## ROCKY FLATS SITE REGULATORY CONTACT RECORD

**Purpose:** Exploratory excavations to greater than 3 feet below grade generally between the former Interceptor Trench Pump House and Solar Ponds Plume Treatment System

**Contact Record Approval Date:**  
May 20, 2008

Figure 1. Approximate Location of TMST Transfer Line

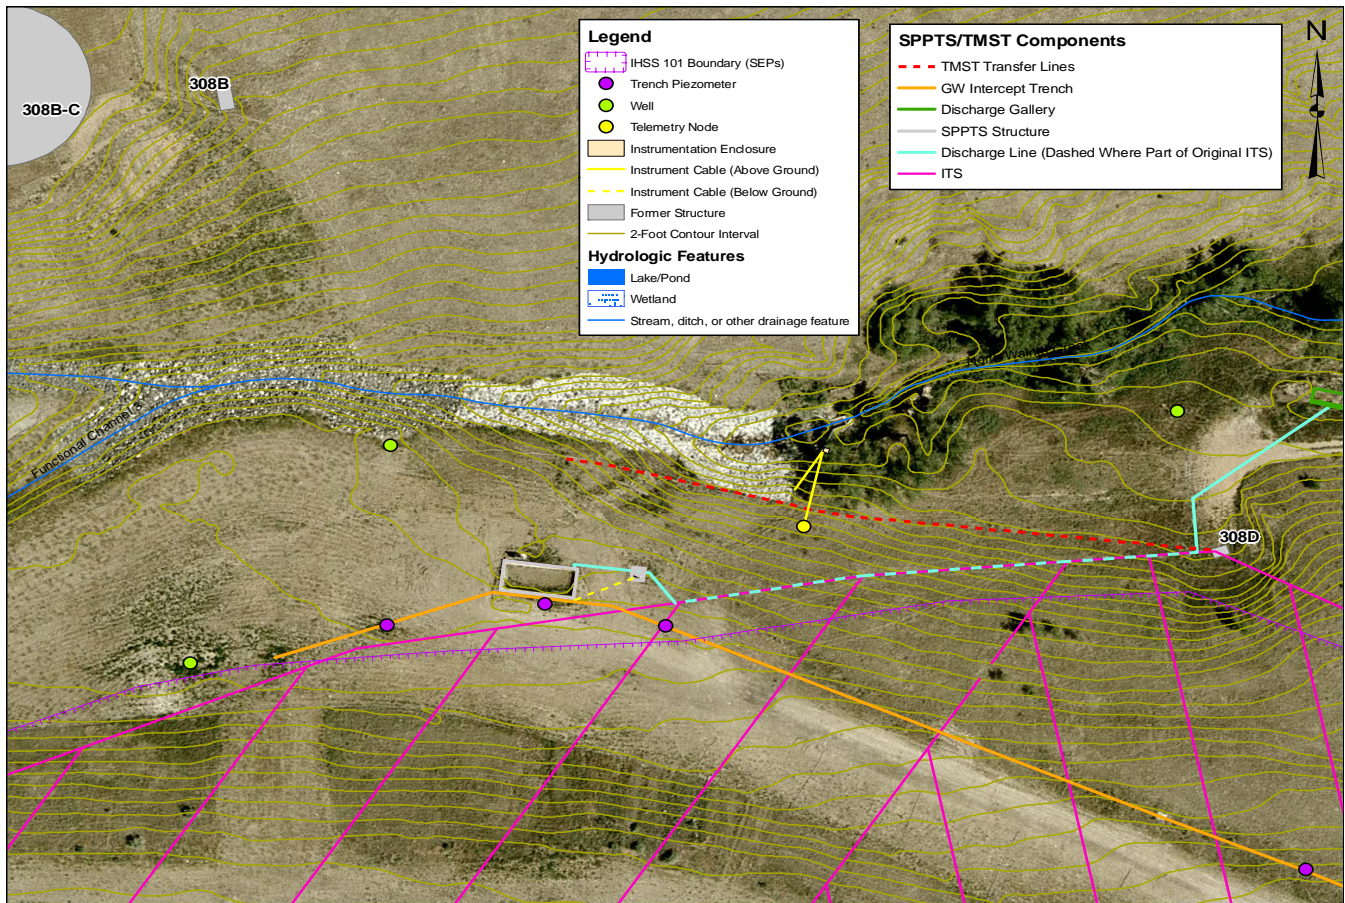
Engineering drawings that were generated before closure depict these lines as double-walled and show them running from the ITPH to the vicinity of the SPPTS before turning more northerly toward the TMSTs. They may be buried closer to the base of the hill (i.e., nearer surface water monitoring station SW093 than the SPPTS itself). Figure 1 shows the approximate location of the TMST transfer lines in relation to other features in the area. Regardless of whether the nearest portion is closer to the SPPTS or SW093, if these lines are in serviceable condition, they should be considered for use in the upcoming SPPTS modifications. Using them to transfer water from the new collection sump to the SPPTS could significantly reduce how much habitat is disrupted: the most sensitive portion of the habitat along the valley bottom, from the general vicinity of SW093 to the new sump, would not be directly impacted by the construction activities.

CDPHE has requested that the following information be included in contact records for soil excavation:

*1 - Provide information about any remaining subsurface structures in the vicinity so that the minimum cover assumption won't be violated (or state that there are none if that is the case)-*

*2 - Provide information about any former IHSSs/PACs or other known soil or groundwater contamination in the vicinity (or state that there is no known contamination)-*

*3 - Resurvey any new surface established in subsurface soil, unless sufficient existing data is available to characterize the surface (or state that the excavated soil will be replaced and the original contours restored)*

The exploratory excavation is in the vicinity of the former ITPH, known as building 308D. The building was removed as documented in the *Type 1 Facility Closeout Report for Buildings 308B and 308D* (September 22, 2003). The closeout report indicates that utilities were disconnected and capped three feet below grade.

The closeout report indicates that there is no contamination present in the remaining soils and that this area was not an IHSS. The *RI/FS Nature and Extent of Soil Contamination* figures do not indicate soil contamination in this area. Groundwater in the vicinity is impacted by the Solar Ponds Plume. Any groundwater that is encountered will be collected from the excavation, if necessary, to conduct the investigative work. The groundwater will be pumped from the excavation to the surface generally south of the excavation area to allow this water to seep back into the ground.

All excavated soils will be returned to the excavation, and original contours will be restored.

**Resolution:** Carl Spreng, CDPHE, approved the potholing work as described in this contact record.
